Proposal for supplement 04 to the 01 series of amendments to Regulation No. 21 (Interior fittings)

Submitted by the experts from France

The text reproduced below was prepared by the experts from France. It proposes an amendment to UN Regulation No. 21 to clarify rounded edges requirements for opening roof parts. The modifications to the current text of UN Regulation No. 21 are marked in bold for new characters and strikethrough for deleted characters.

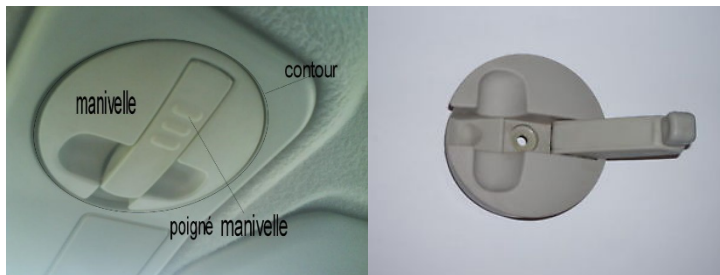
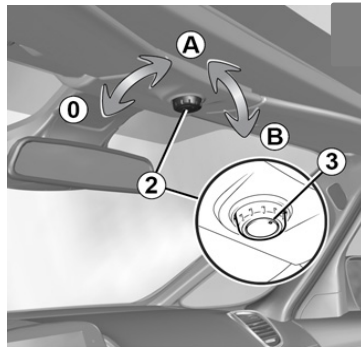
1. Opening roof operation devices shall fulfill the requirement of § 5.5.1.2.2. (radius above 5mm). The other control levers (non structural parts) implemented on the roof are under the specifications of § 5.3.4.1. (radius above 3,2mm).
2. When an electric opening roof operating device includes other functions, as for example shadowing curtain control, it shall comply with the requirements of both paragraphs. § 5.5.1.2.2. was initially defined to specify adapted requirements for manual opening roof crank handle. Specifications of § 5.3.4.1. are more adapted to electronic control devices, for opening operation or other functions.

Manual : requirements of § 5.5.1.2.2. applicable

Electric including other functions : requirements of § 5.5.1.2.2. and § 5.3.4.1. are applicable.

By keeping only manual devices under paragraph 5.5.1.2., these electrical devices (with one or both functions) are only under paragraph 5.3. requirements without geometrical compatibility issue and safety use is kept.

Paragraph 5.5.1.2, amend to read:

"5.5.1.2. In addition, the **manual** opening and operating devices shall : [...]"
